Access Compliance Report

Public Rights-of-Way

(Curb Ramps)

Intersection ID: 45096	Main Street: E_9TH_ST	Cross Street: N_DAVIDSON_ST	Location: SE
ADA ID: 4297EDCC7F7C	Ramp Type: MedianPerp	Initial Pass/Fail: Fail	Overall Compliance: No
Severity Score: 13.75			
Codes/Mitigation Info/Possible Solution		Field Measurements/Component Compliance

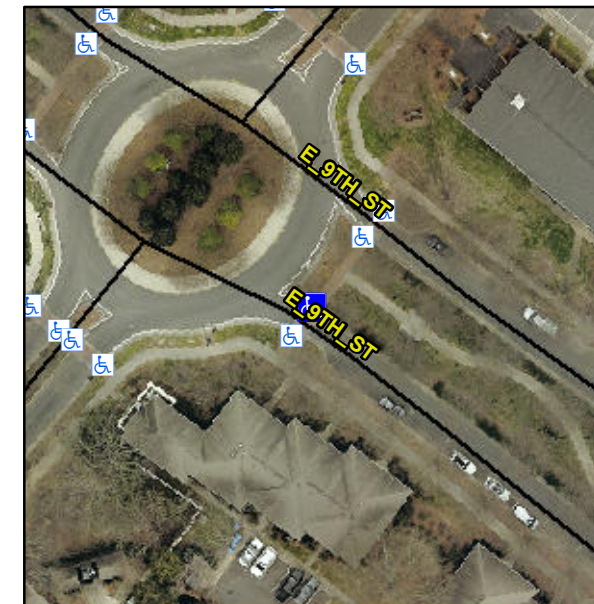
Compliance	Description	Data	Compliance	Description	Data
N/A	Ramp Length (in)	69.0	No	Ramp Slope (%)	10.1
Yes	Ramp Width (in)	71.0	No	Ramp XSlope (%)	2.7
N/A	Flare Type LT	N/A	N/A	Flare Type RT	N/A
N/A	Flare Slope LT (%)	N/A	N/A	Flare Slope RT (%)	N/A
N/A	Flare Traversable LT?	N/A	N/A	Flare Traversable RT?	N/A
N/A	Landing Length (in)	N/A	N/A	DWS Provided?	N/A
N/A	Landing Width (in)	N/A	N/A	DWS Contrast?	N/A
N/A	Landing Slope (%)	N/A	N/A	DWS Length (in)	N/A
N/A	Landing X Slope (%)	N/A	N/A	DWS Full Width?	N/A
N/A	Landing Curb? (Y/N)	N/A	N/A	DWS Offset (in)	N/A
N/A	Shared Landing?	N/A			
N/A	Gutter Ponding?	N/A	N/A	Gutter Slope (%)	N/A
N/A	Gutter Lip Ht (in)	N/A	N/A	Gutter X Slope (%)	N/A
N/A	Painted X Walk1?	Yes	N/A	Painted X Walk2?	N/A
	X Walk 1 Direction	To S		X Walk 2 Direction	N/A
N/A	X Walk 1 Width (in)	82.0	N/A	X Walk 2 Width (in)	N/A
	X Walk 1 Slope (%)	1.2		X Walk 2 Slope (%)	N/A
	X Walk 1 X Slope (%)	2.0		X Walk 2 X Slope (%)	N/A

N/A	Ramp inside XWalk1?	Yes	N/A	Ramp inside XWalk2?	N/A
	Road Slope (%)	N/A	N/A	Clear Space?	N/A
	Road X Slope (%)	N/A	N/A	Clear Space to XWalk (in)	N/A
N/A	Any Obstructions?	N/A	N/A	Storm Grate/Utility Hazard?	N/A
	Obstruction Type			Storm Grate/Utility Type	
		N/A			N/A
		Yes		Surface Condition? (G/P)	Good

Remove & Replace Entire Ramp.
